ADDENDUM NO. 2

TO: PLANS AND SPECIFICATIONS FOR STATE OF MISSOURI

**Renovate Interior
General Headquarters Complex
Jefferson City, MO
PROJECT No.: R2410-01**

P-101

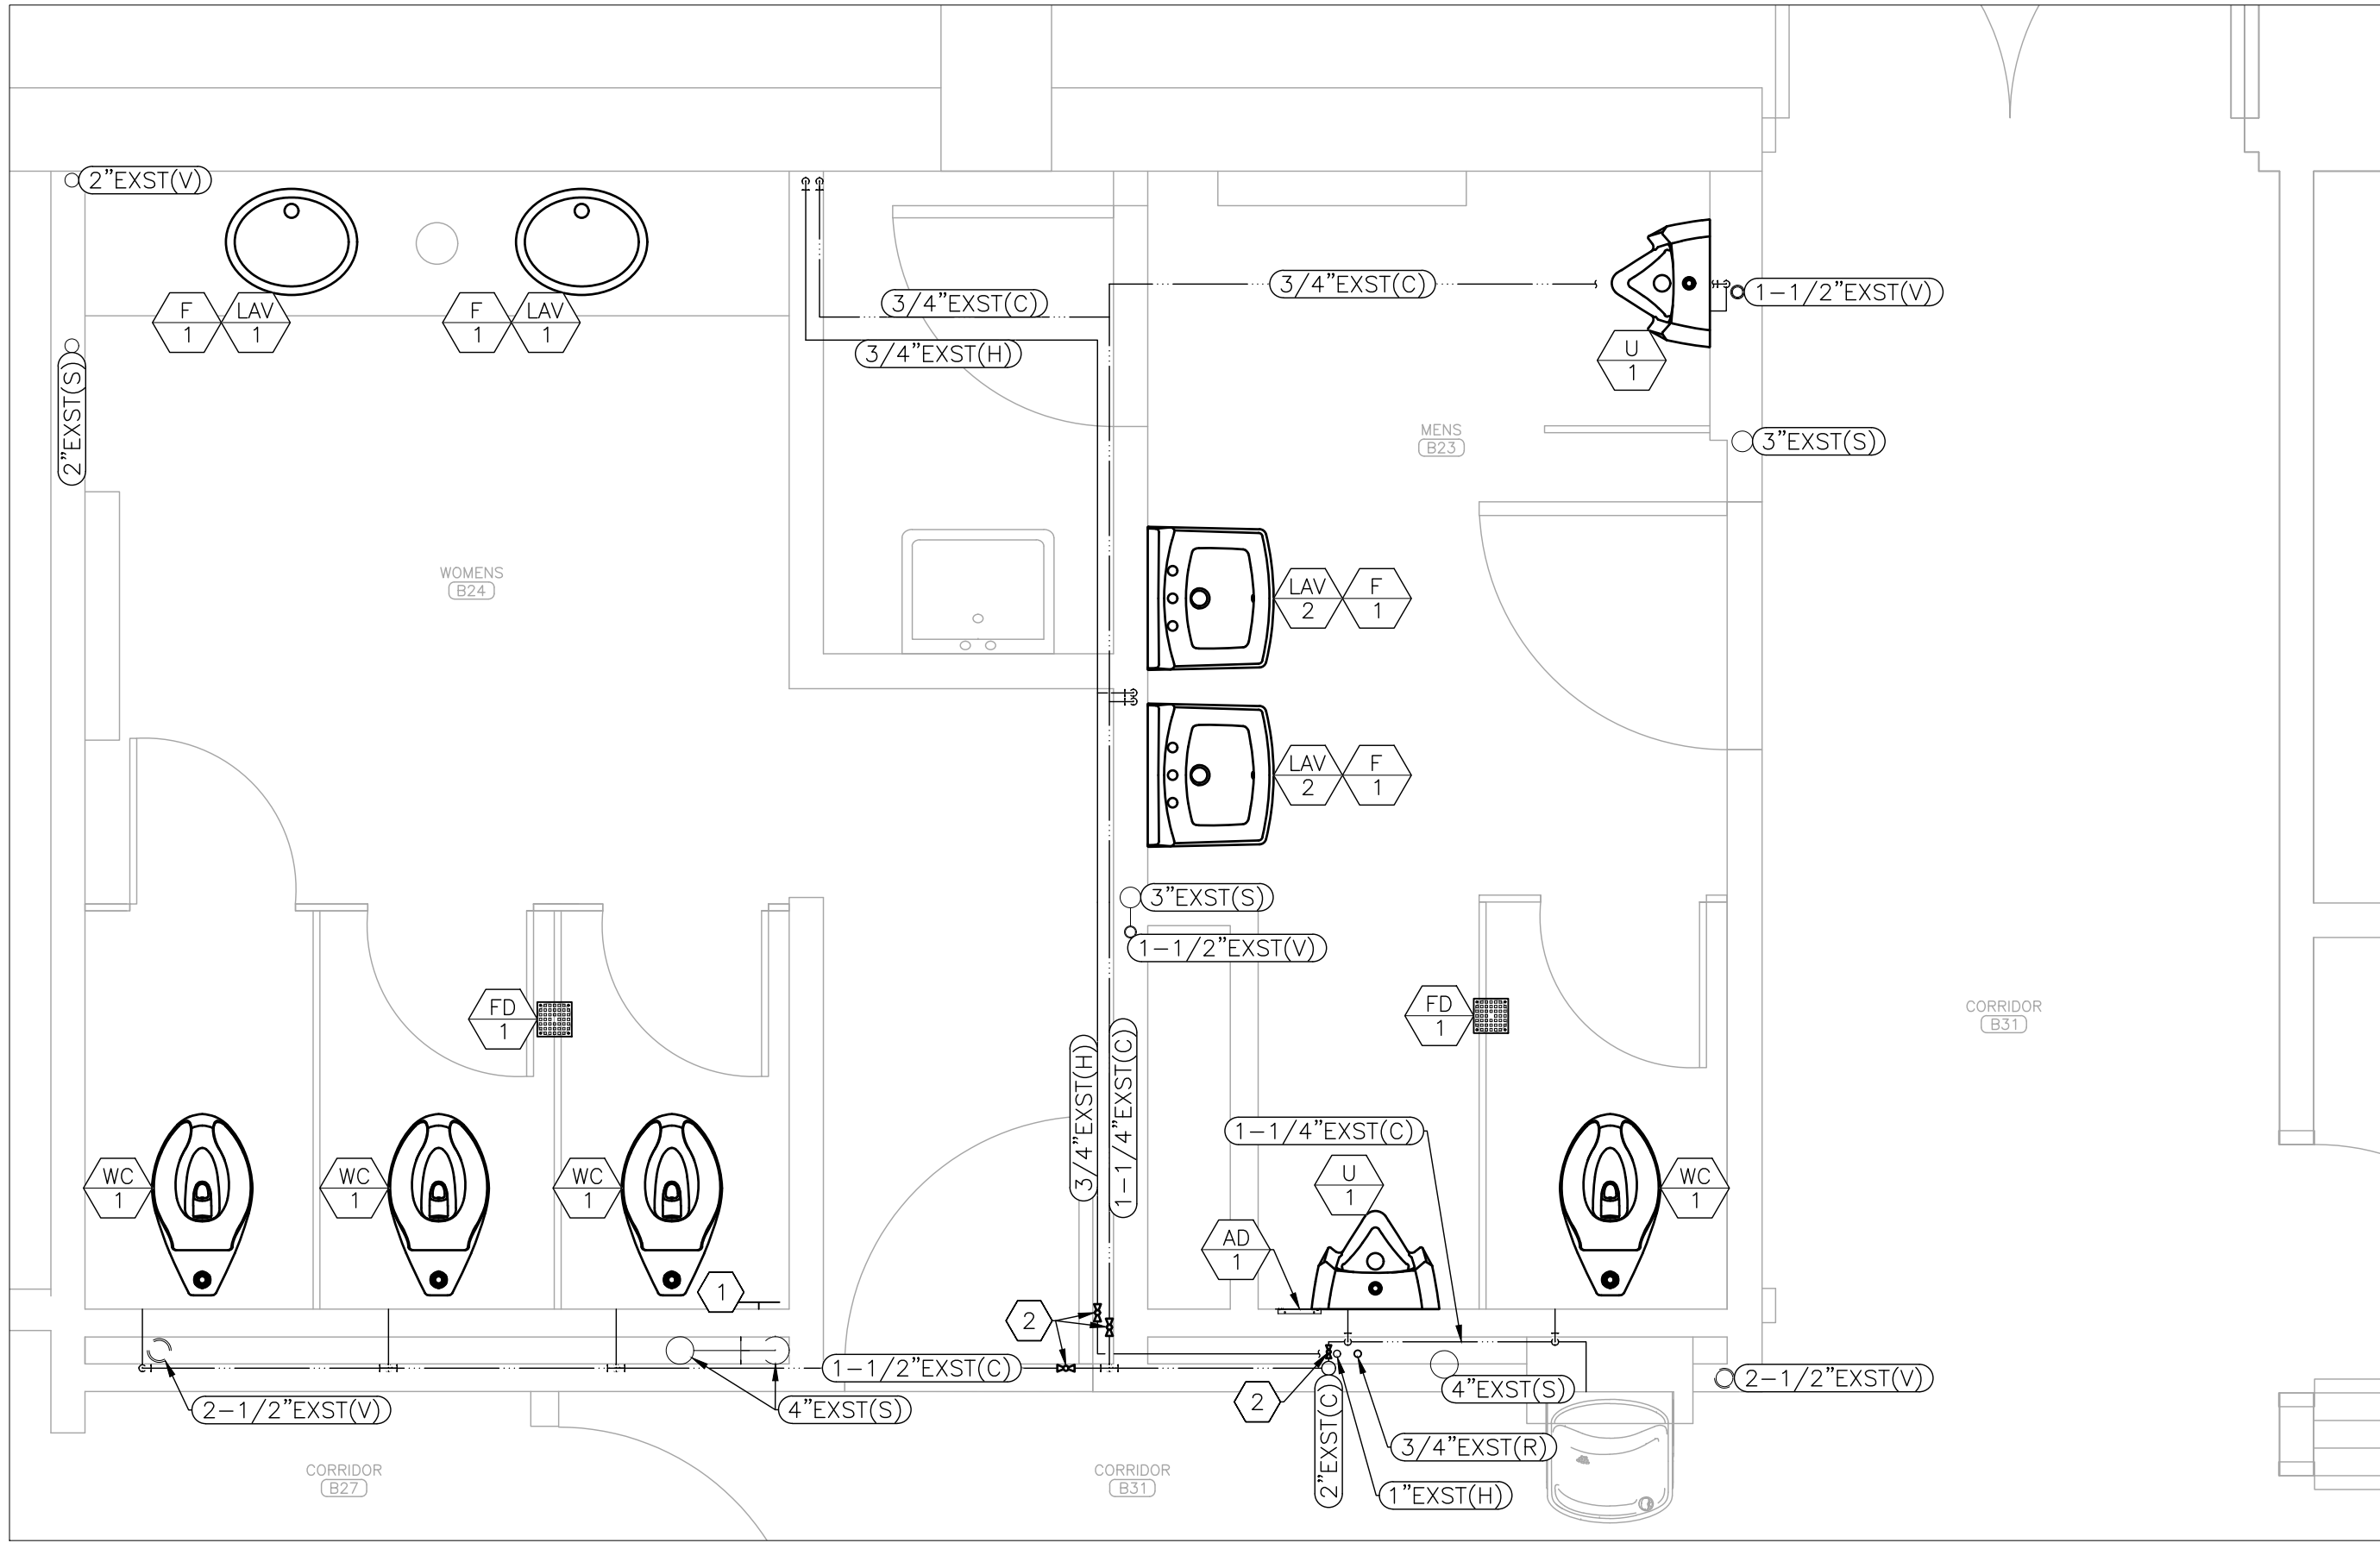
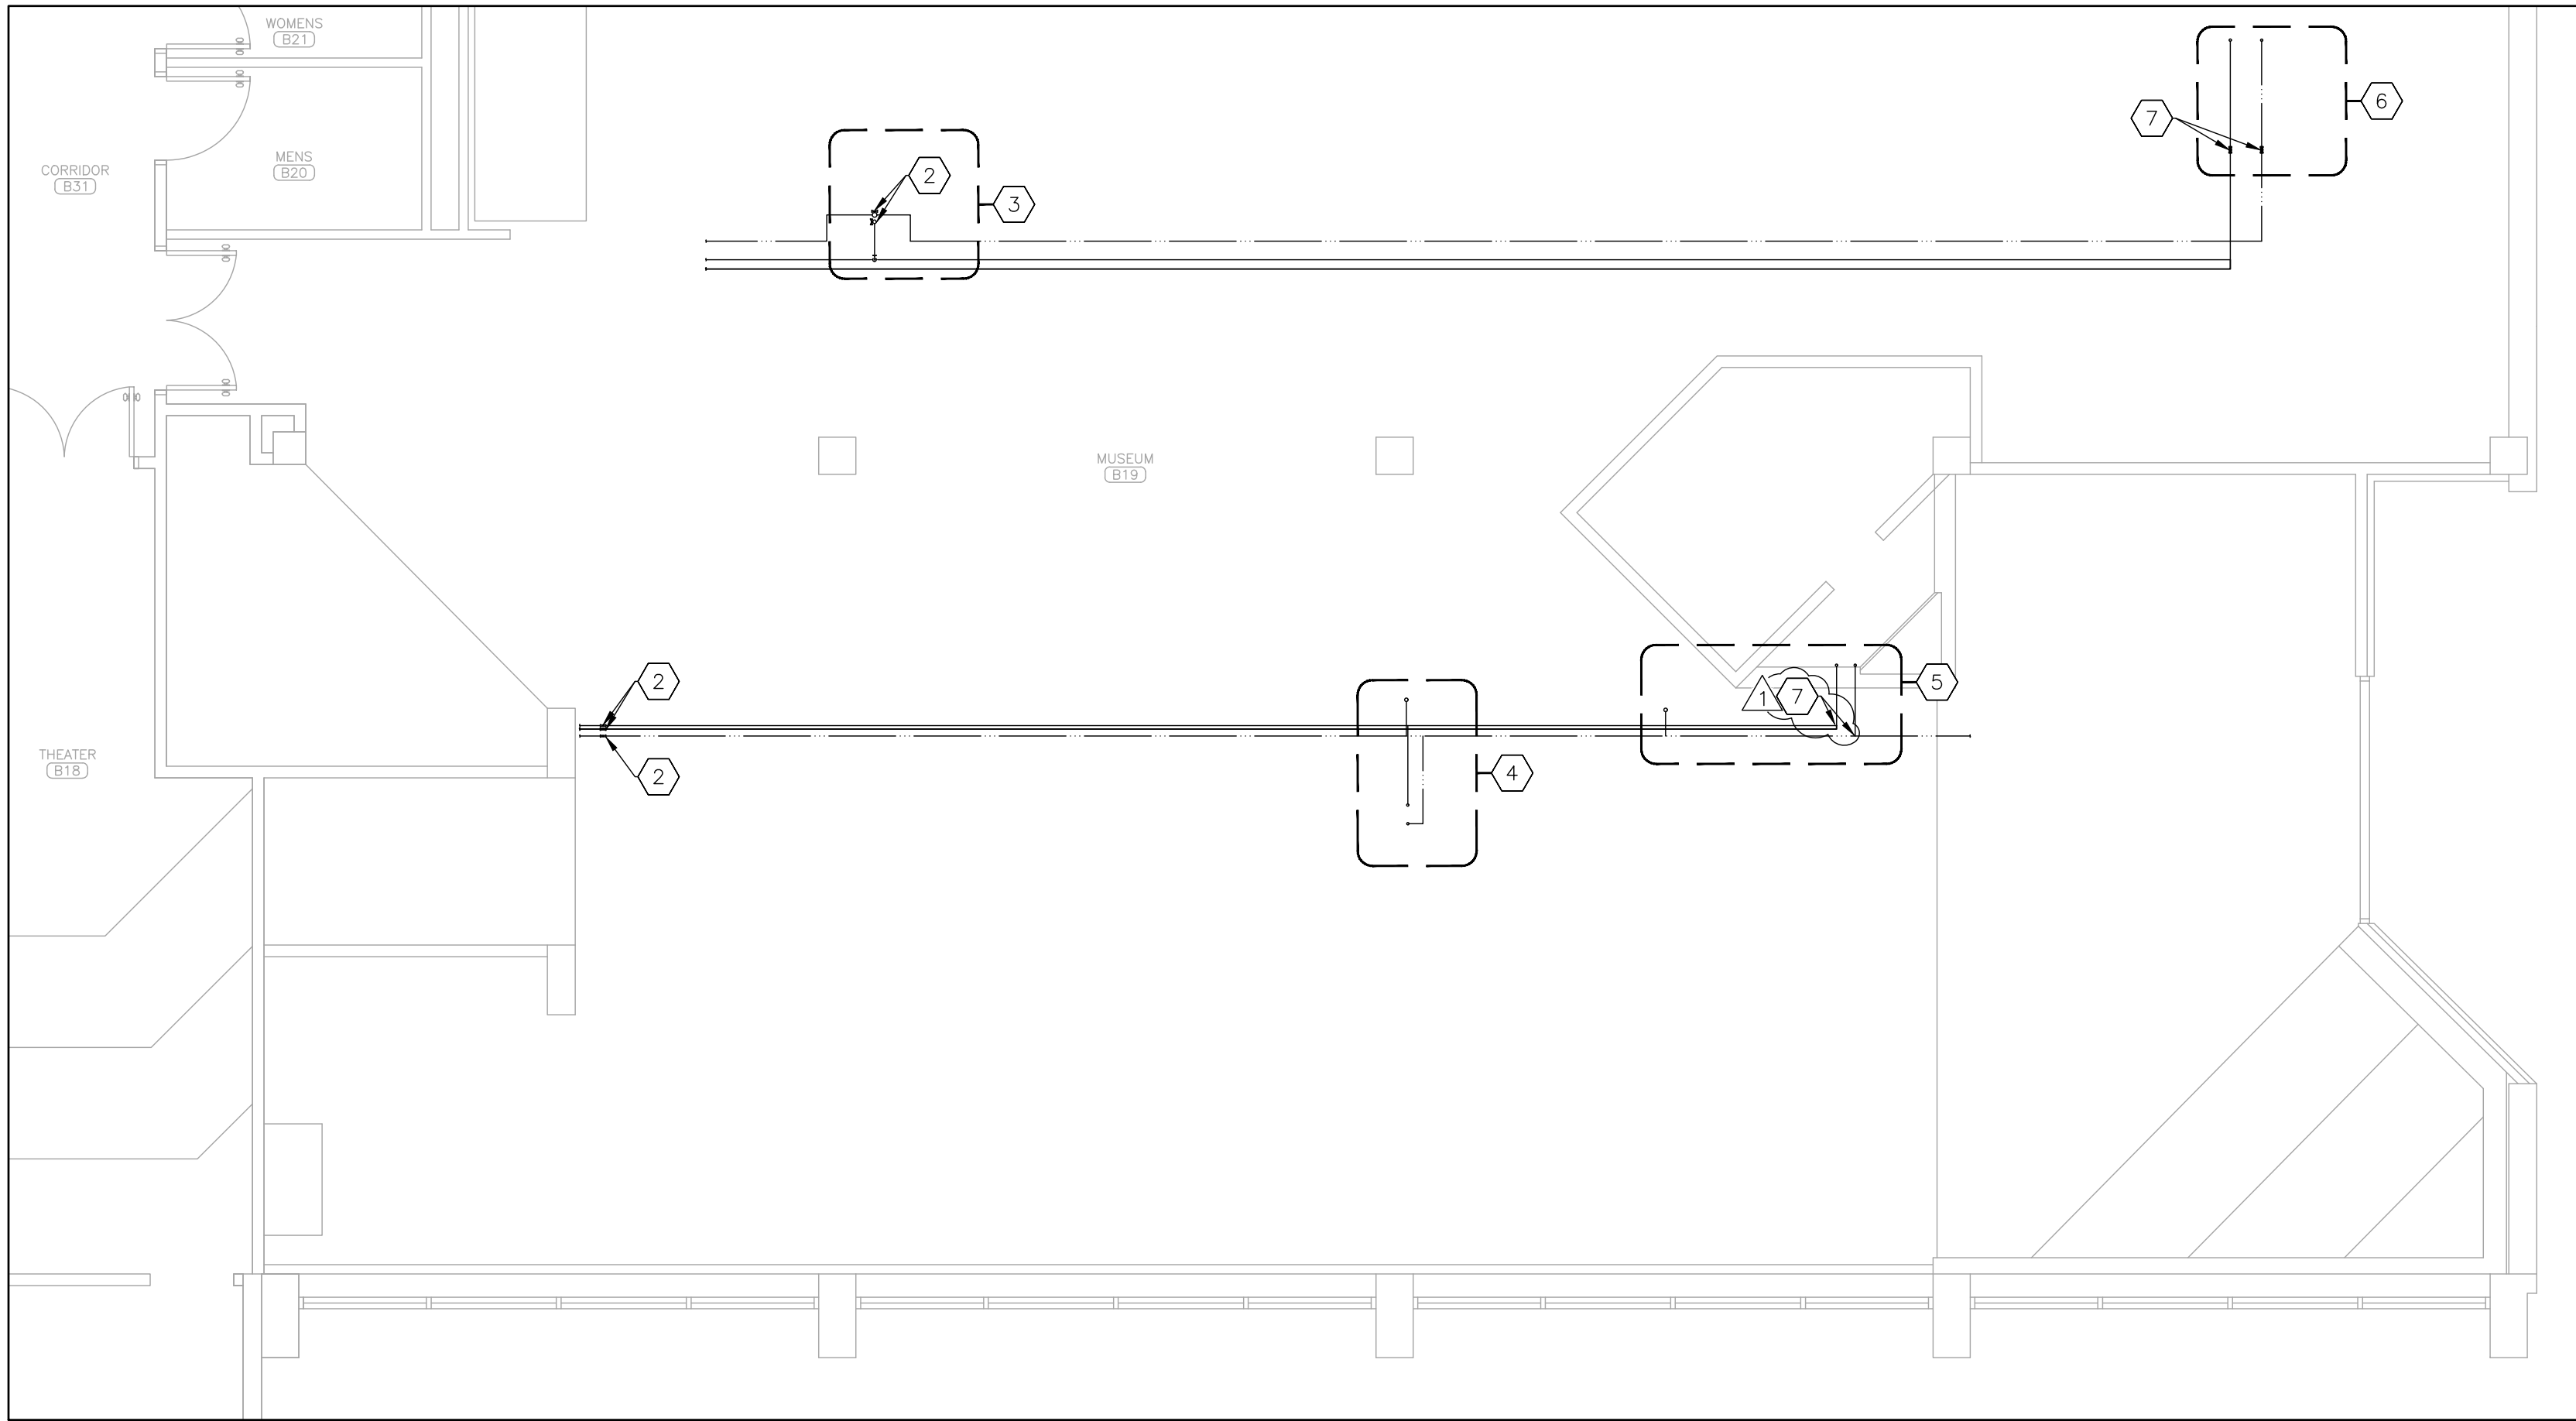
1. P-101: Add Demolition Keynote 10.
2. P-104: Add Demolition Keynote 7.

- LABEL PLUMBING PIPE FITTINGS AS CONTAINING ASBESTOS.
